May 12, 2015
Medway Planning and Economic Development Board
155 Village Street
Medway, MA 02053

Tri Valley Common – Public Hearing Continuation:

RE: TRI VALLEY COMMONS SITE PLAN
DRC INTERIM LETTER OF RECOMMENDATION REVIEW

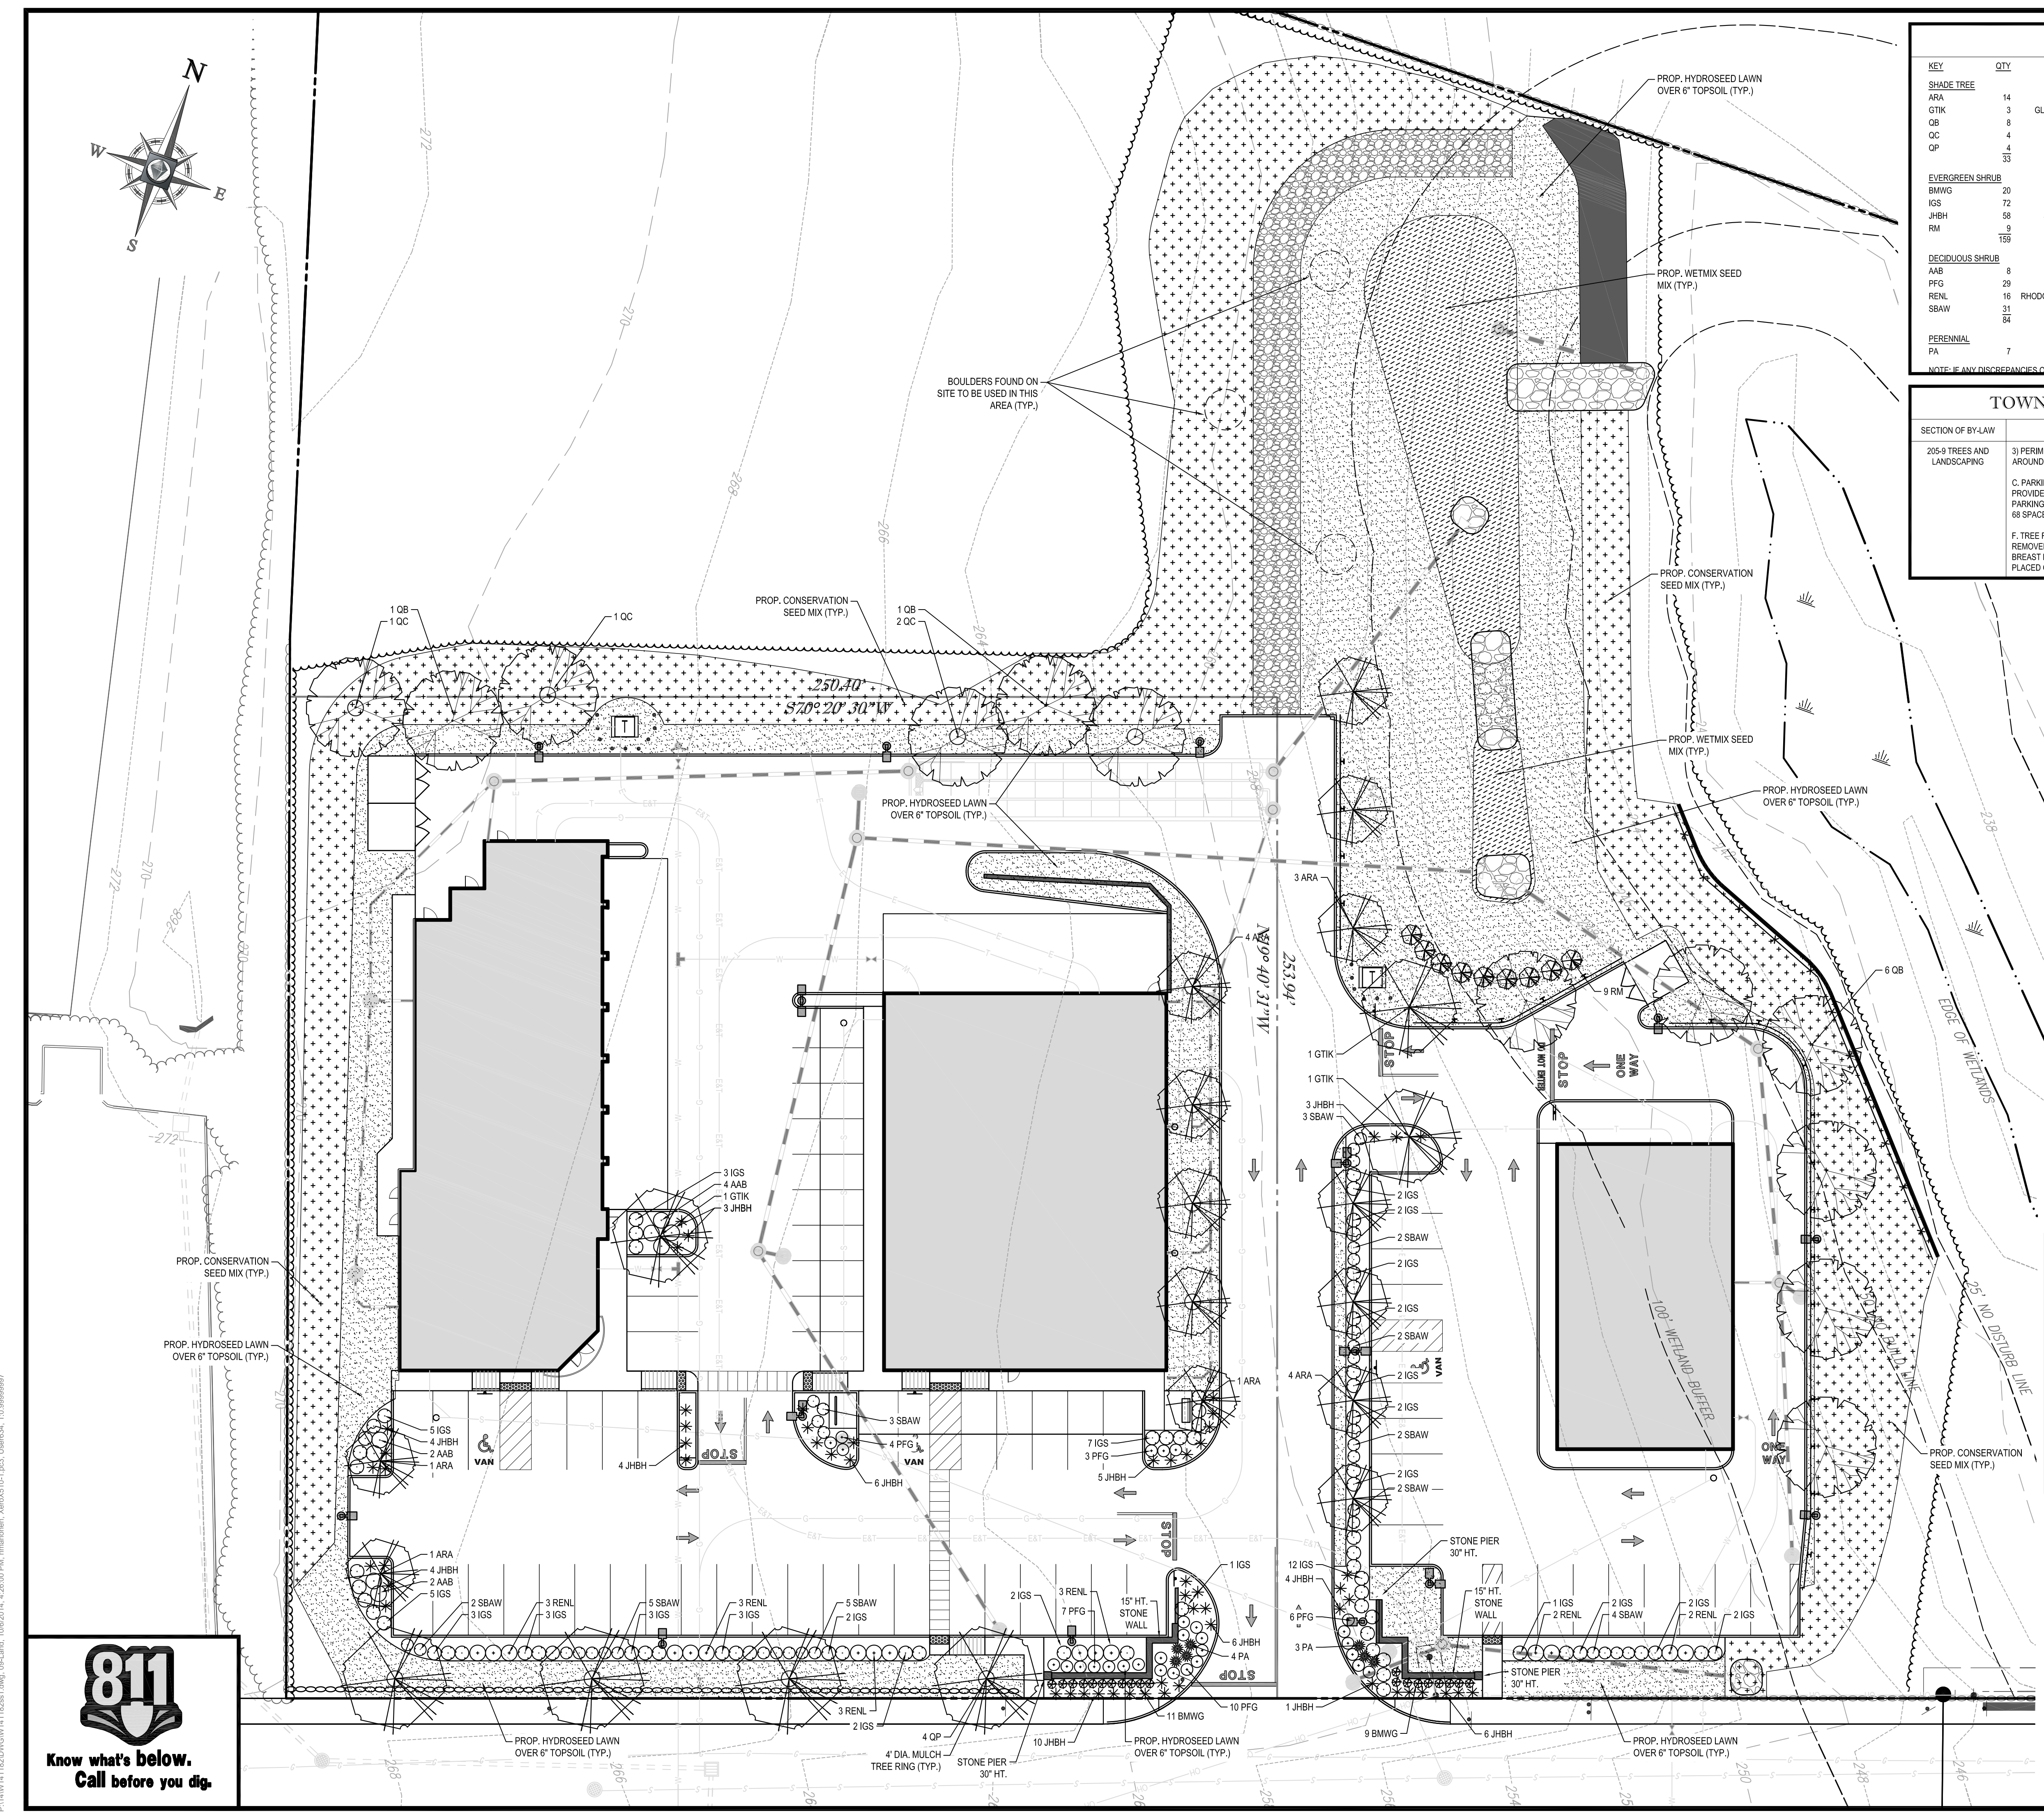
- The final and crucial element to mitigate the length of Building A is landscaping, some of which is inaccurate or absent on the current plan set. The items needing further attention are:

1. The DRC awaits an inventory of existing trees on the West side of the site to identify trees to be saved and to specify any new plantings.
 2. To provide a four-season screen, the applicant created a planting area just southeast of the first garage bay in which a large coniferous tree would be placed. The applicant has indicated that this specimen evergreen tree will be vertical in form and 20' tall at time of planting. Current plans indicate this is a deciduous honey locus. The plans should be updated to reflect the recommendation as agreed.

Note: Please refer to page 9 of the site plan provided May 1st 2015 and dated 1/9/2015, last revised 4/27/15.

PVC FENCE TRASH ENCLOSURE

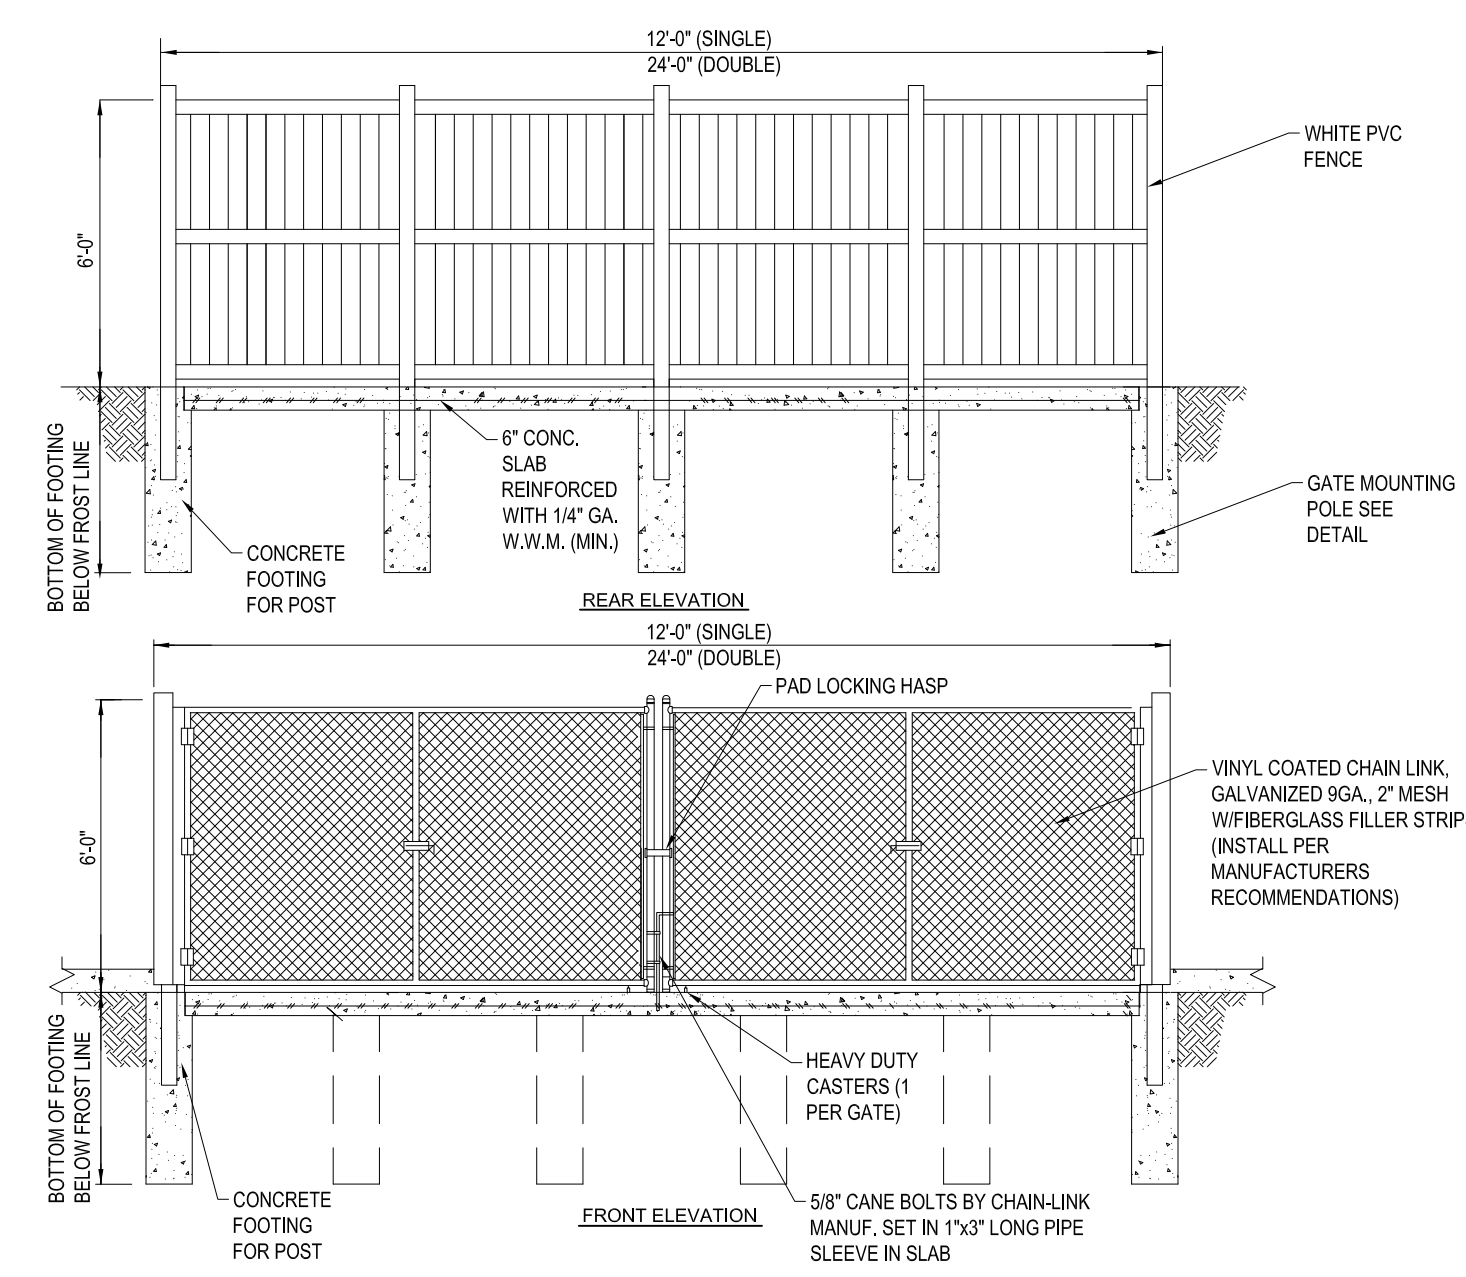
- White fence should extend around all four sides of dumpster enclosures, to provide complete screen. This is in place of chain link fronts to the enclosures.
- Pedestrian crossings should be painted, stamped asphalt rather than zebra stripe.
- Sample images and specs of ornamental lighting fixtures should be supplied.
- Positions of ornamental lighting fixtures should be shown.
- Ornamental lights should be placed at the front of site to relate to roadway.
- Details of monument sign at entryway should be provided.
- The DRC recommends that the sign be incorporated or coordinated with the stone wall along the front site boundary.
- Details of public trash receptacles should be provided.
